HOWIE POINT (NORTH 1)
FROM STA 0+00.00
TO STA 28+00.00

MEADOW RANCH II & III

GRADING & EROSION CONTROL PLAN COVER SHEET

C1.12 PROJECT 61209
MVE DRAWING GEC-ED

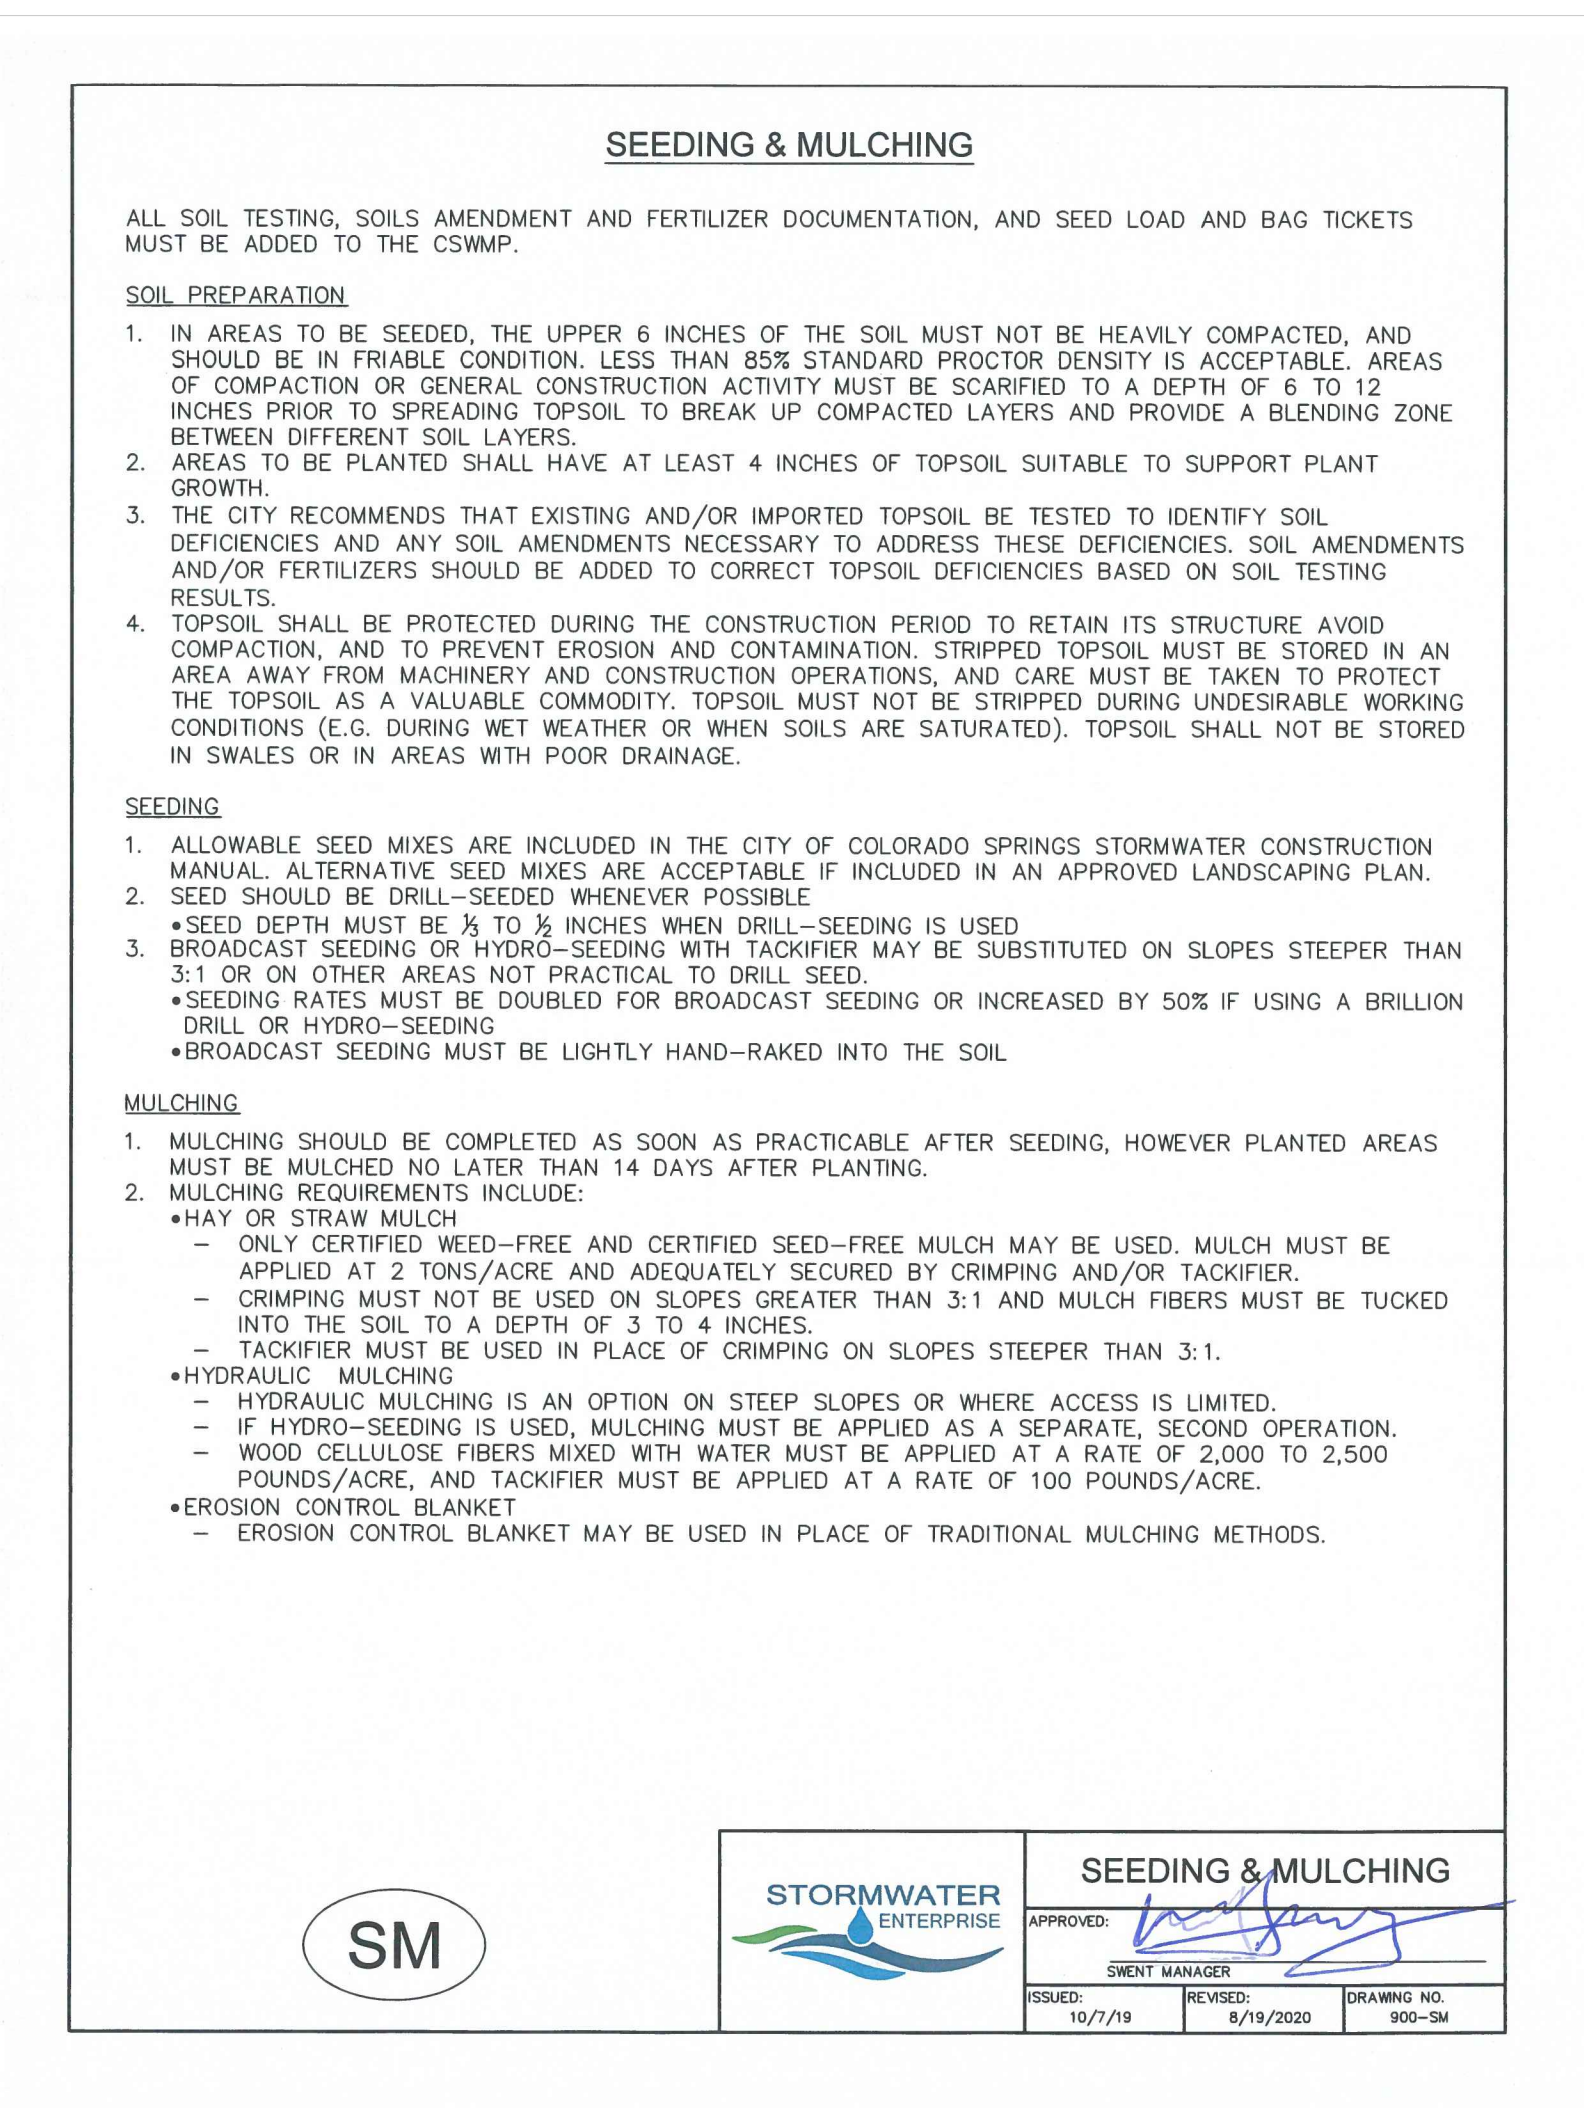
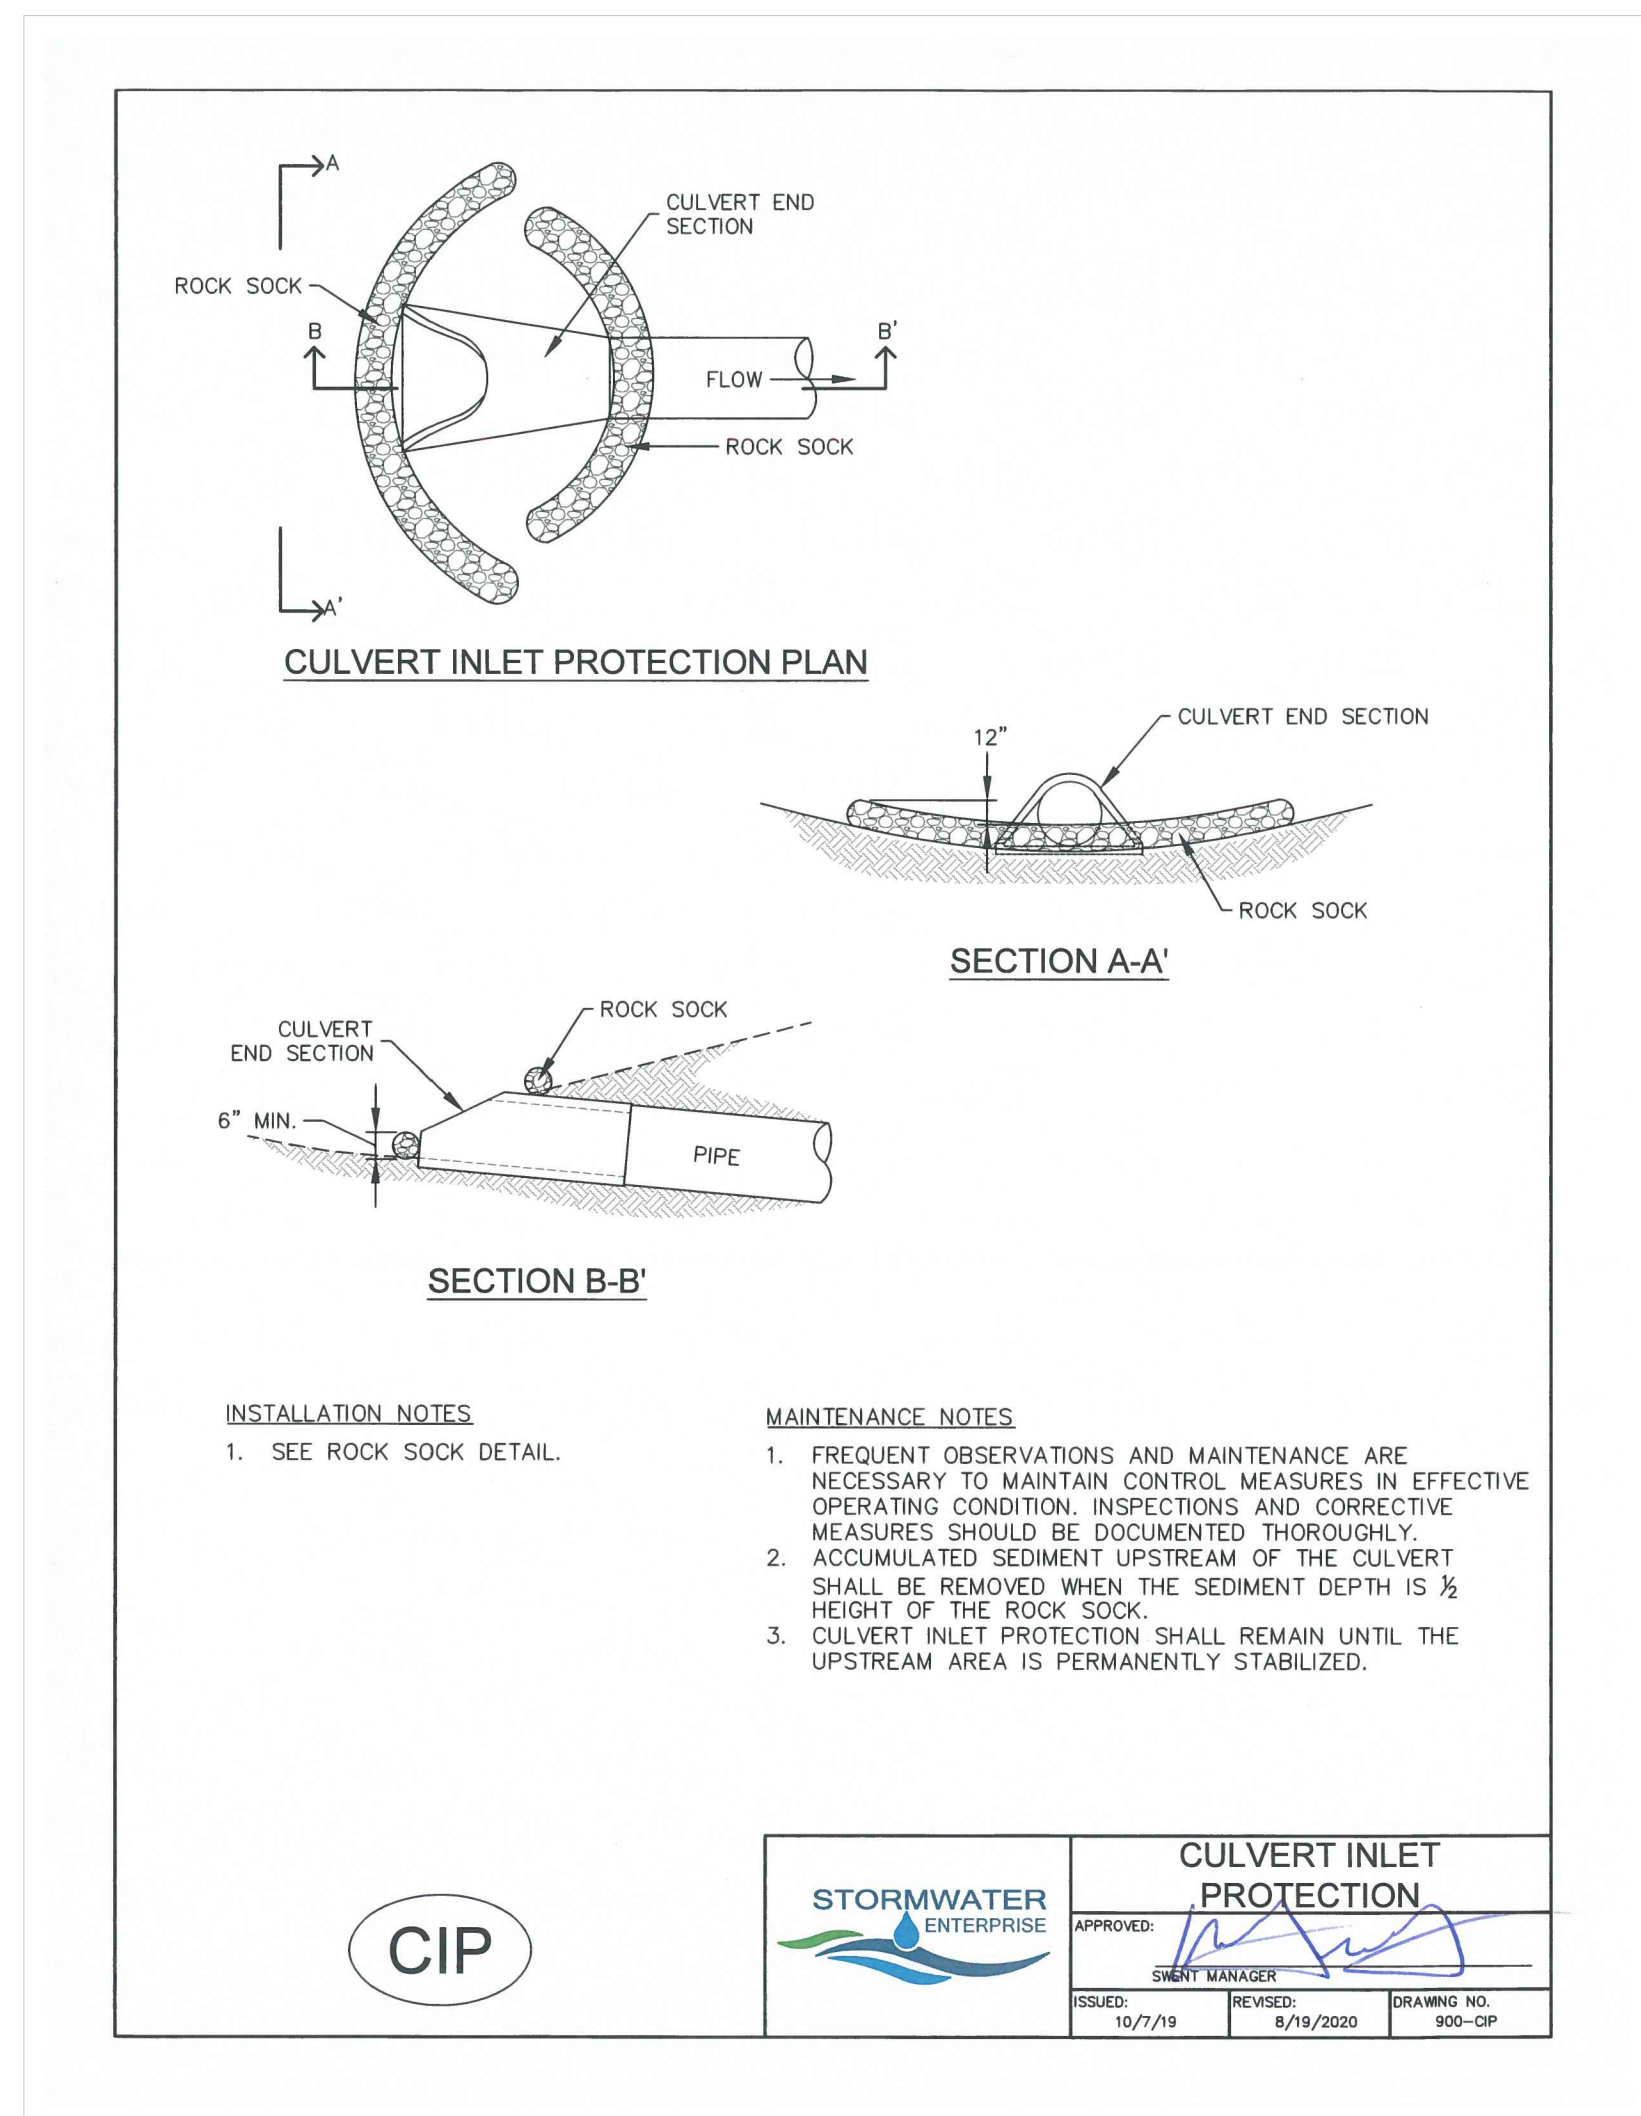
Add details for stabilized staging area, soil stockpiles, and TSB details.
